THE TRAILS FILING NO. 9

LOCATED IN THE SOUTH HALF OF SECTION 17, TOWNSHIP 12 SOUTH, RANGE 64 WEST OF THE 6TH PRINCIPAL MERIDIAN COUNTY OF EL PASO, STATE OF COLORADO

JOB NO. 25175.02
SEPTEMBER 21, 2022
SHEET 1 OF 5

PCD FILE NO. SF-21-036

JOB NO. 25175.02
SEPTEMBER 21, 2022
SHEET 2 OF 5

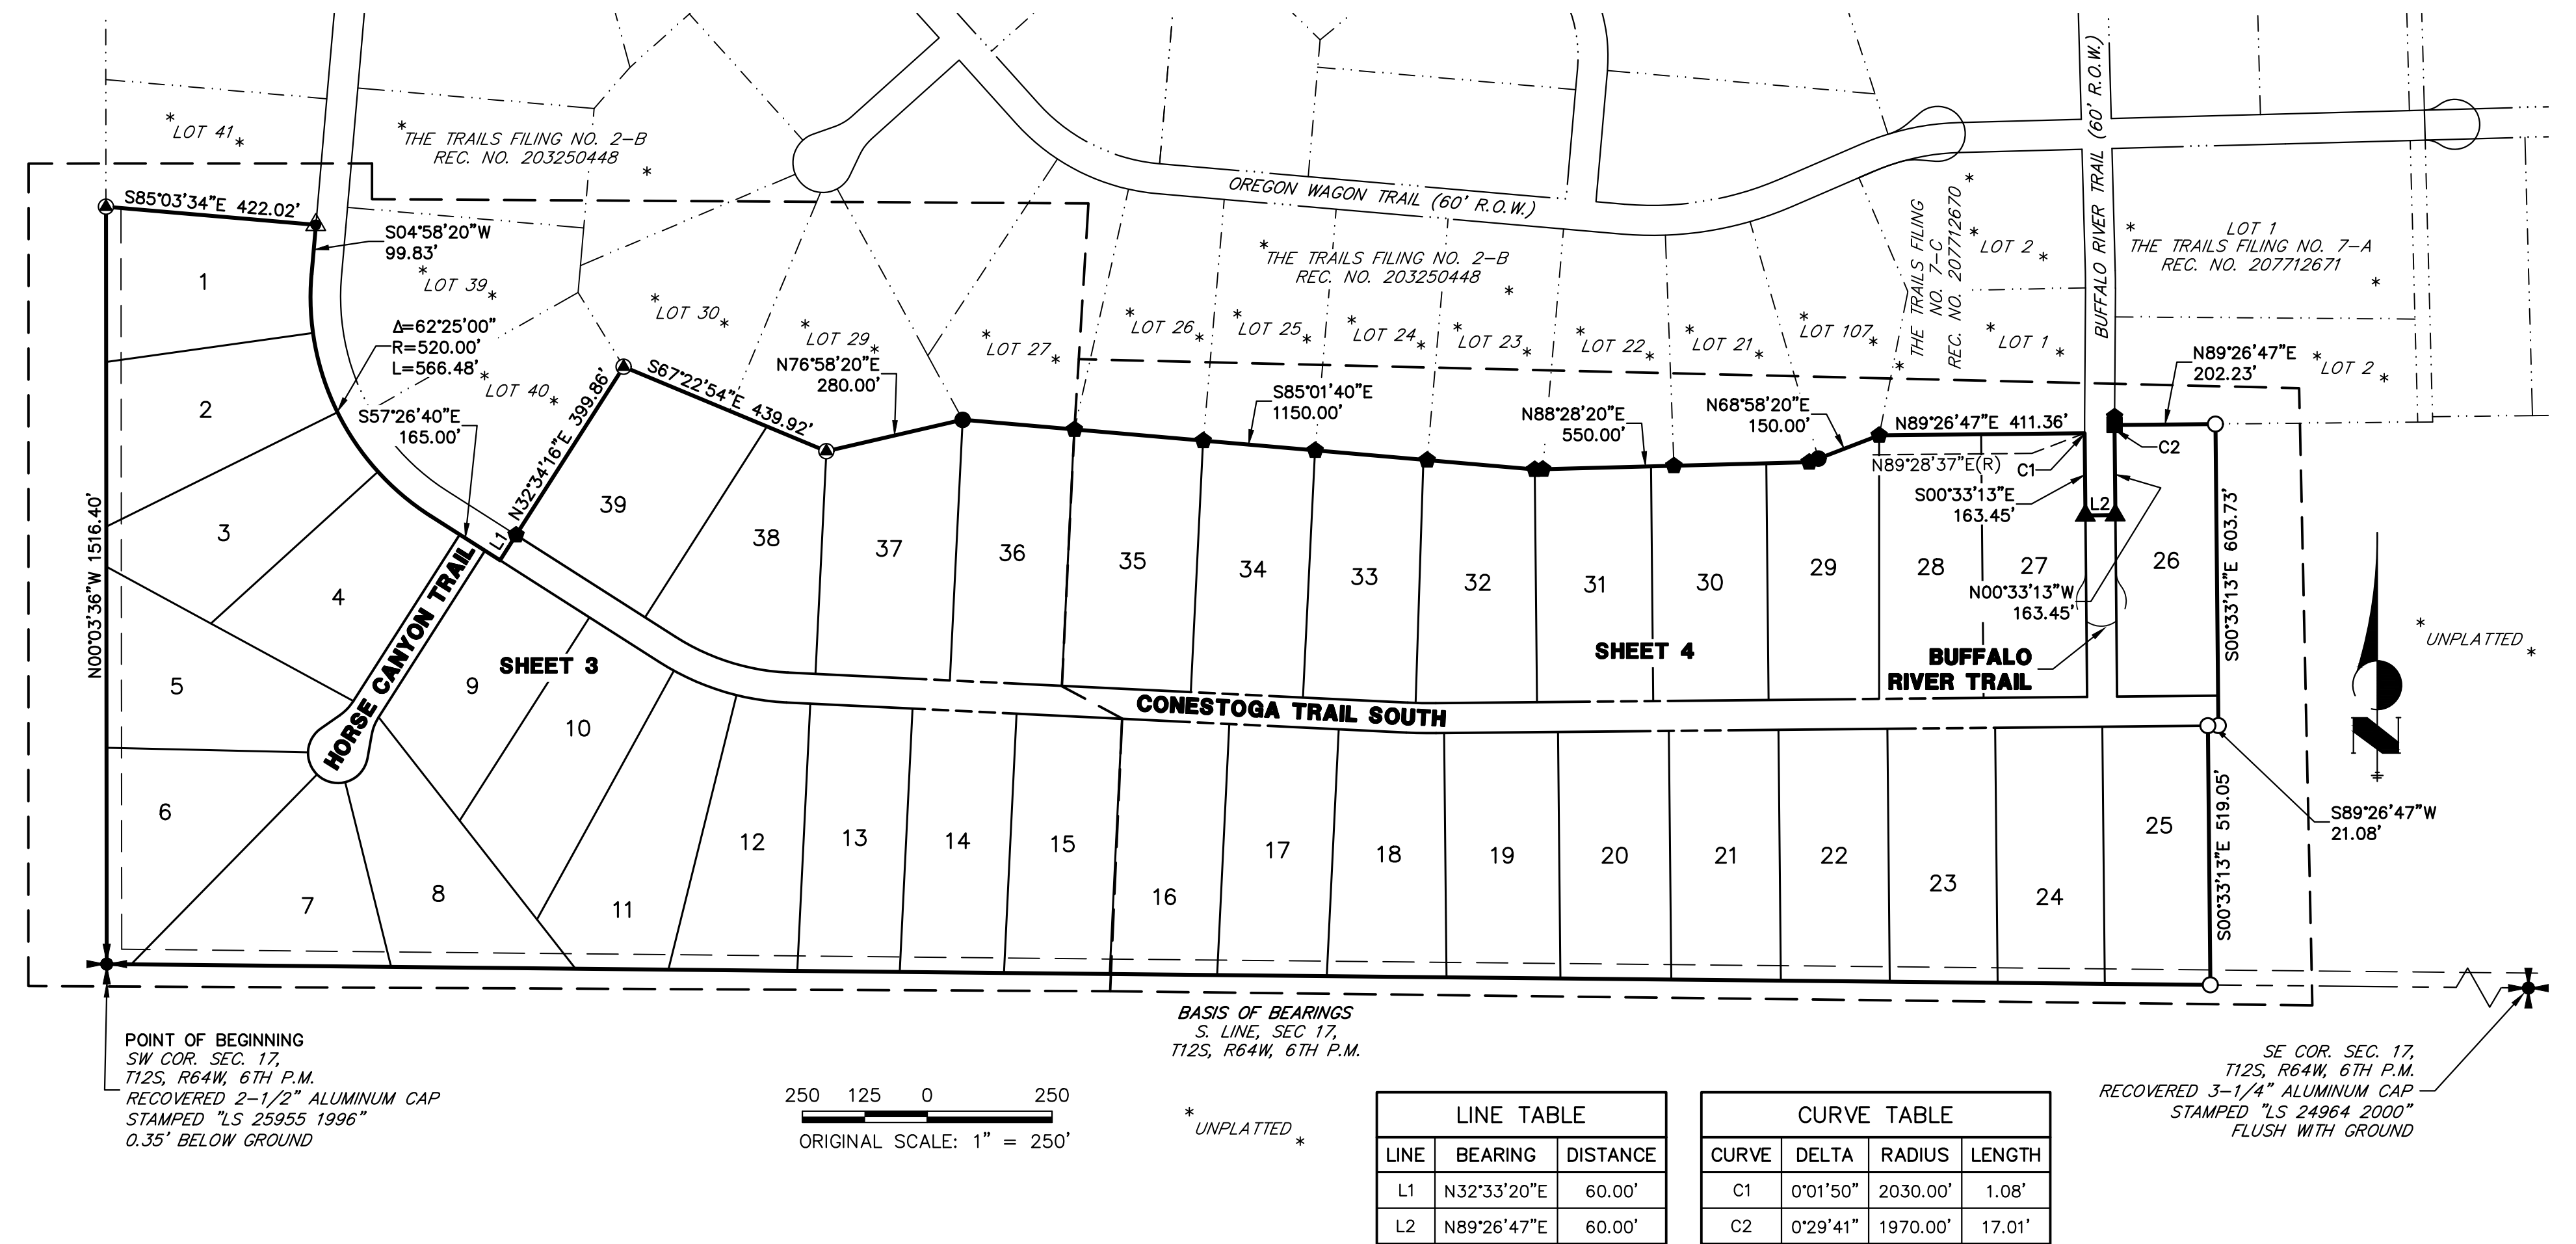
This should be discussed in the LOI also under the approval criteria... has the District provided and documentation that they are in agreement? WHO realistically maintaining the drainage ways on the properties, private property owners tend to NOT maintain the drainage ways causing up stream damages (flooding/erosion if drainage is blocked by homeowner). - Is the district to maintain these?

80 40 0 80
ORIGINAL SCALE: 1" = 80'
JOB NO. 25175.02
SEPTEMBER 21, 2022
SHEET 4 OF 5

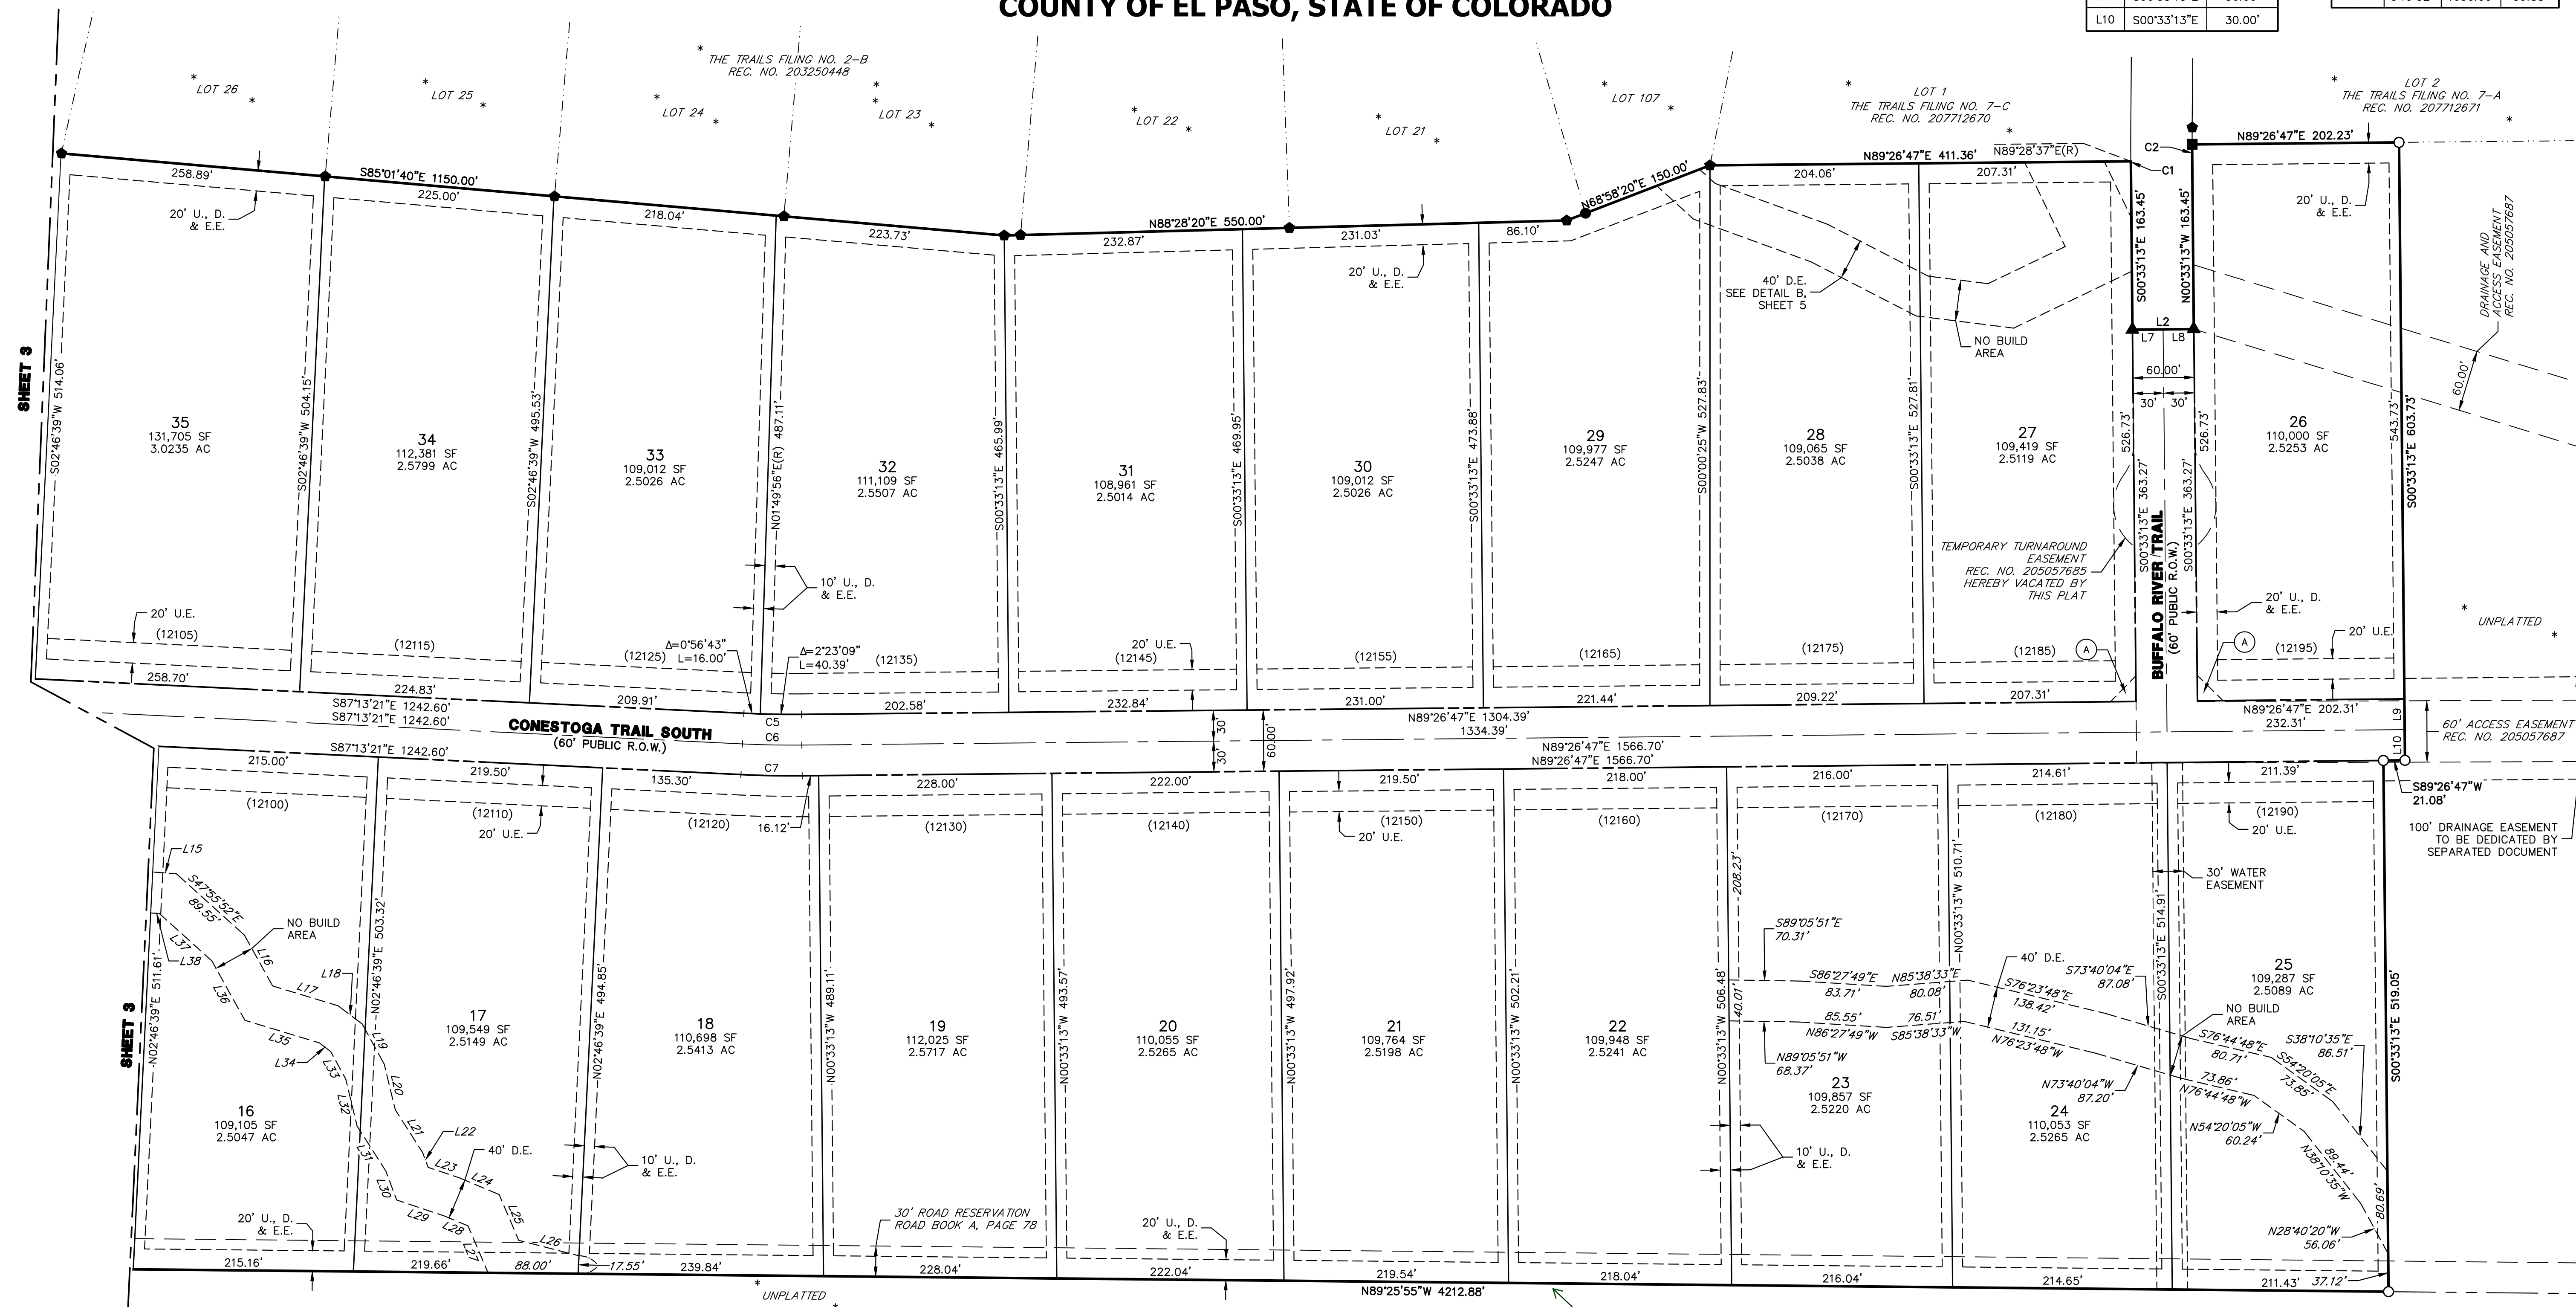
adjacent property owners and zoning for all plat boundaries per the checklist is needed

adjacent property owners and zoning for all plat boundaries per the checklist is needed
